**Statement of Response to An Bord Pleanála's Opinion
in relation to Reg. Ref.: ABP-307010-20**

A Proposed Strategic Housing Development

Golf Lane, Carrickmines, Dublin 18

John Spain Associates

Figure 1: Extract from HJL Design Statement illustrating the height context analysis

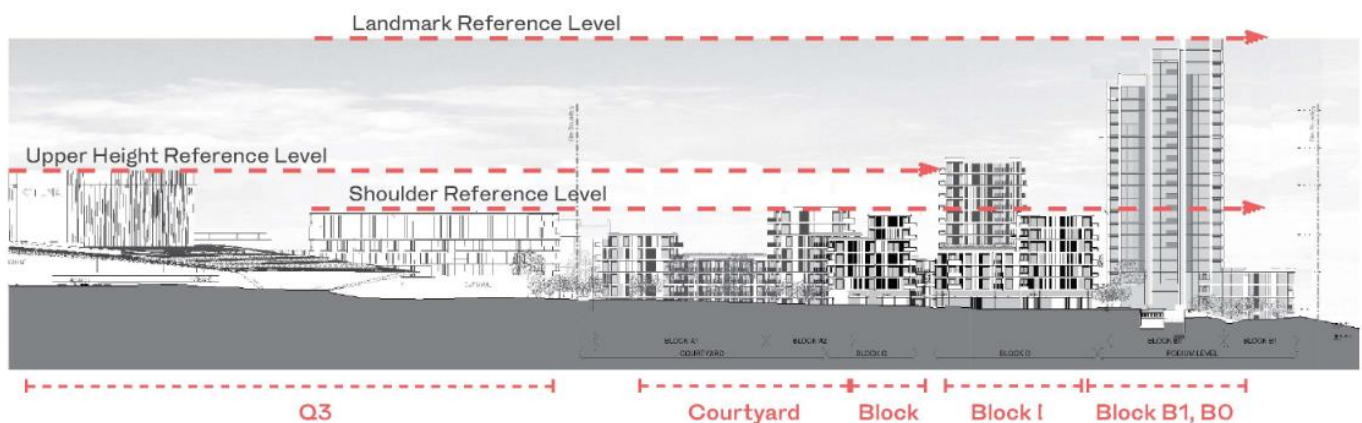
"Further consideration and/or justification of the documents as they relate to the height and design strategy. In this regard, the prospective applicant should satisfy themselves that the design strategy for the site as it relates to height, in the context of the concerns raised by the PA in relation to the 12-storey element (Block A3), provides the optimal architectural solution for this site and should submit a rationale/justification for the heights/setbacks proposed. Further justification/consideration of the documents as they relate to the overall block structure and the relationship between the blocks (height/scale/massing/proportions) should also be submitted.

This exercise revealed that, when viewed in the context of surrounding development and topography, the shoulder height set by the permitted Quadrant 3 development (DLR Reg. Ref.: D18A/0257 and ABP Reg. Ref.: 304369-19) corresponds with the height set by Block A2, C and D within the proposed development at Golf Lane. This height comparison informed and is considered to form part of the justification for the height of these elements of the proposed development.

When the nearby height precedent of the top level of the permitted Quadrant 3 scheme is taken into account while accounting for topography, the overall height of that development corresponds closely to the 12 storey element of the proposed development (Block A3).

Figure 9: Extract from the final layout for the main east-west pedestrian/cycle route

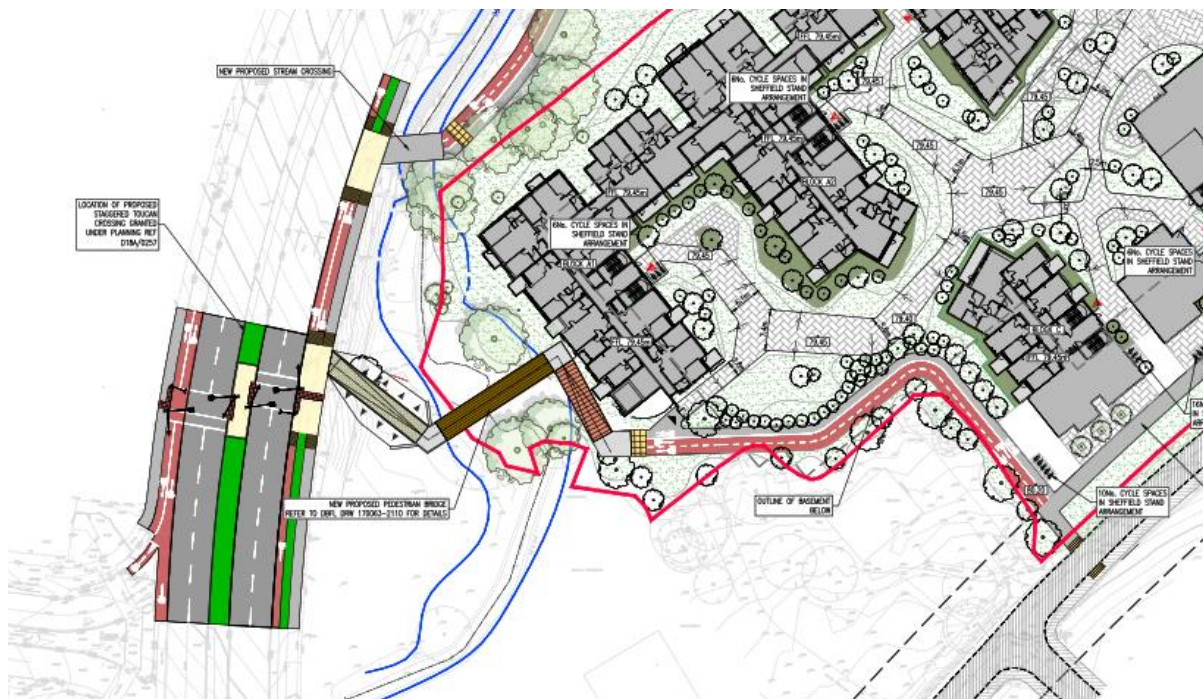
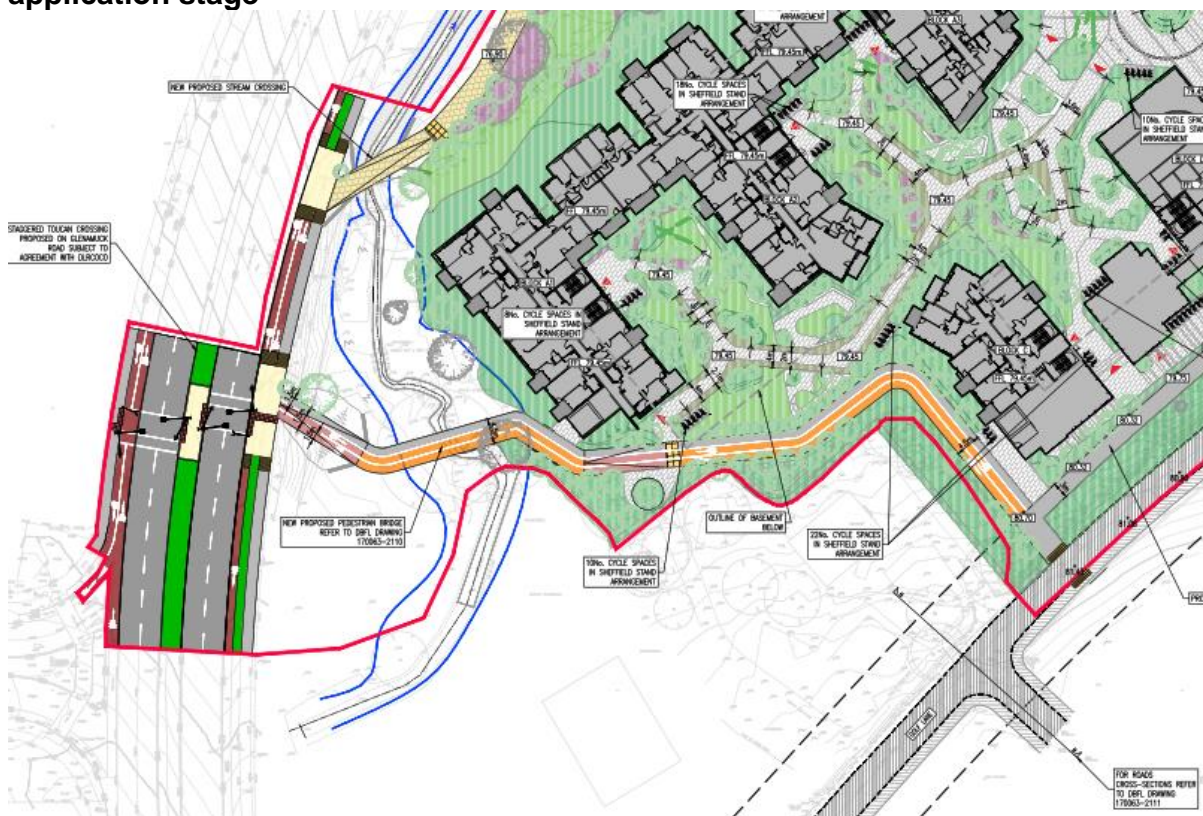
“Further consideration of documents as they relate to the layout of the proposed development particularly in relation to permeability and the criteria set out in the Urban Design Manual relating to ‘Connections’ which accompanies the Guidelines for Planning Authorities on Sustainable Residential Development in Urban Areas and the Design Manual for Urban Roads and Streets. The configuration of the layout particularly as it relates to the creation of a legible pedestrian/cycle pathway from the Glenamuck Road through to Golf Lane should be given further consideration. Proposals for pedestrian access across the Glenamuck Road should also be examined.”

The alignment of this route has been modified to make it significantly more direct. The amended layout has realigned the route to avoid the inclusion of a sharp turn to the southwest of Block A1. The revised layout allows for a significantly more legible route which turns more gently within the site, allowing for good visibility along the route for pedestrians and cyclists.
